**A RESOLUTION OF THE CITY COUNCIL OF
THE CITY OF MERCED, CALIFORNIA,
ADOPTING THE MERCED VISION 2030
GENERAL PLAN**

Merced Vision 2030 General Plan

**MERCED VISION 2030 GENERAL PLAN
OPTION 2**

Proposed Changes Since August 2010 Public Review Draft

FIGURE 2.0-4

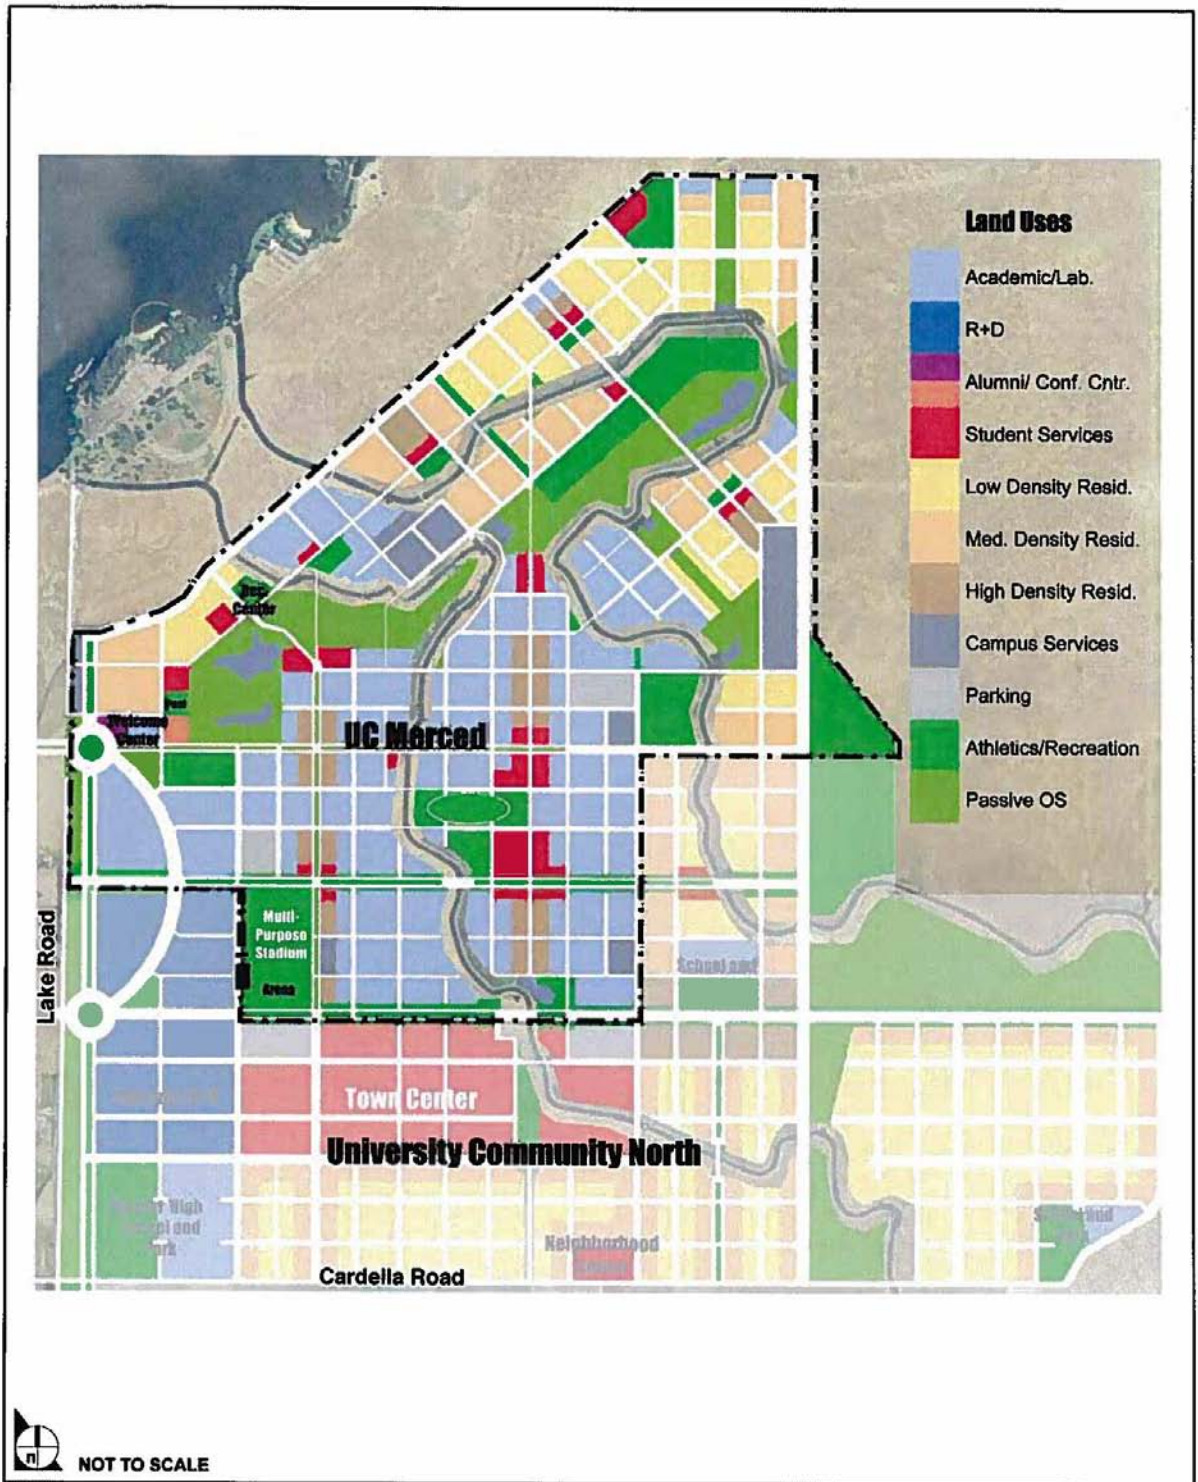
#	Pg.	¶	Col.	Change	Source
1	--	--	--	Various Figures, Maps, and Table throughout the General Plan document will be modified to reflect the 2009 UC Merced and University Community North boundaries as adopted by the UC Board of Regents in 2009. This will include changes to the Land Use Diagram and SUDP/SOI boundary for those areas only. See Exhibit 1 for the 2009 UC/UCP boundaries.	CS/UC
